Appendix 1 – Detailed Concerns w/ Supporting Images

IMAGE 01

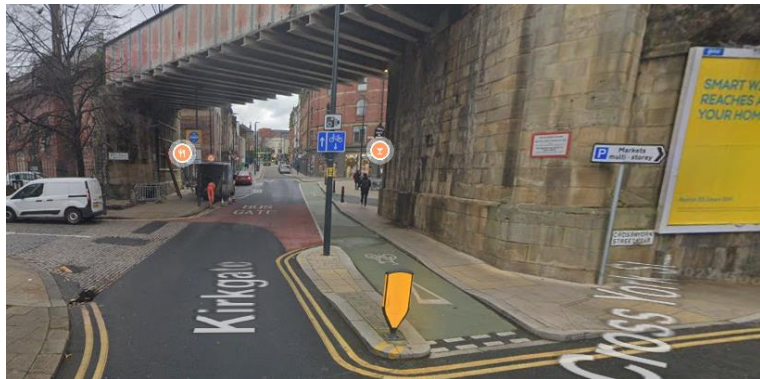
Kirkgate		<p>My comments are entirely concerned with the works to the Kirkgate Viaduct(HUL4/47) and Marsh Lane Viaduct (HUL4/44) at Penny Pocket Park in Leeds City Centre. The Environmental Report NR16: Volume 1 says that “The proposed works involve small-scale electrification and signalling infrastructure within an area of existing railway infrastructure. As such it is not considered that there will be any harm to the Conservation Area or heritage assets that lie within it.” Similarly, the Environmental Report NR16: Volume 3 says “Proposed infrastructure (signal gantry, cabinets and two lock out devices) will be visible in winter and introduce additional detracting features into the view, however, the presence of detracting urban features, such as street lighting columns, road signage, and existing railway infrastructure currently exist in the landscape. Views will be oblique and filtered by existing vegetation. Features remain in context with the urban environment and are unlikely to be immediately apparent to the casual observer”. However, if viewpoint is moved to the junction of Wharf Street and Kirkgate (see extract from Street View below), there is a relatively unobstructed view along the viaduct converging on the grade I Minster. There are overhead lines above the parapet which are lost against the sky, their converging lines emphasising the unobstructed view along the viaduct . The proposed signalling gantry to be introduced at the open arch opposite the tower of the Minster will be a “detracting feature”, standing vertically from the viaduct and breaking the continuity of the view, and will cause “less than substantial harm” (at the lower end of the scale) to the setting of the Minster and the City Centre Conservation Area.</p> <p>The footpath under the Kirkgate underbridge is a dark spot at night and may discourage pedestrian movement along Kirkgate. Improved lighting could encourage movement and assist with the regeneration of Kirkgate and the City Centre Conservation Area. There is support for this in Policy 10 of the Leeds Core Strategy says that proposals will be supported where they accord with the following key principles:</p> <p>(v) The development creates a safe and secure environment that reduces the opportunities for crime without compromising community cohesion,</p> <p>(vi) The development is accessible to all users.</p> <p>In addition, paragraph 92 of the NPPF says that planning policies and decisions should aim to achieve healthy, inclusive and safe places are accessible, so that crime and disorder, and the fear of crime, do not undermine the quality of life or community cohesion.</p> <p>See image 01</p>

IMAGE 12

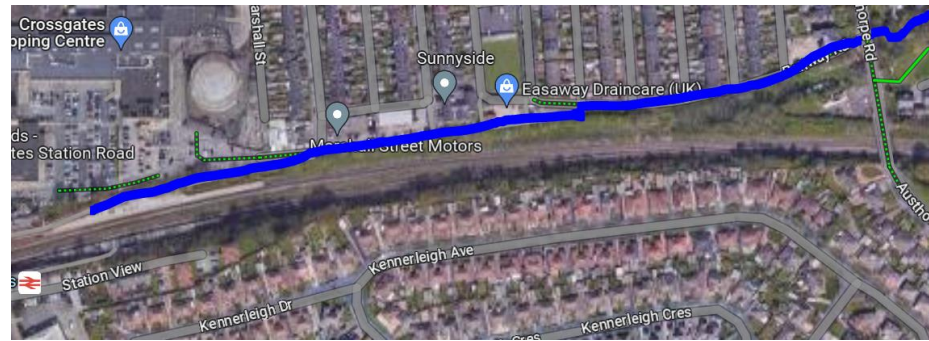
Osmondthorpe		Land appears to be adjacent to development area and would therefore be PD in line with Part 4 Class A of the GPDO. Conditions associated with Class A are: Development is permitted by Class A subject to the conditions that, when the operations have been carried out— (a)any building, structure, works, plant or machinery permitted by Class A is removed, and (b)any adjoining land on which development permitted by Class A has been carried out is, as soon as reasonably practicable, reinstated to its condition before that development was carried out.
Osmondthorpe		1) Recognised as a bike friendly road which is used to connect key communities to Halton Moor 2) Need to ensure we maintain access for cyclist and pedestrians for the duration of the work. 3) Also, important core network bus No. 5 route (single deck) servicing the area (10-15 min frequency) using EV buses – critical to reduce the potential impact on this key service 4) Review width of carriageway – improve provision for walking and cycling under bridge See image 12
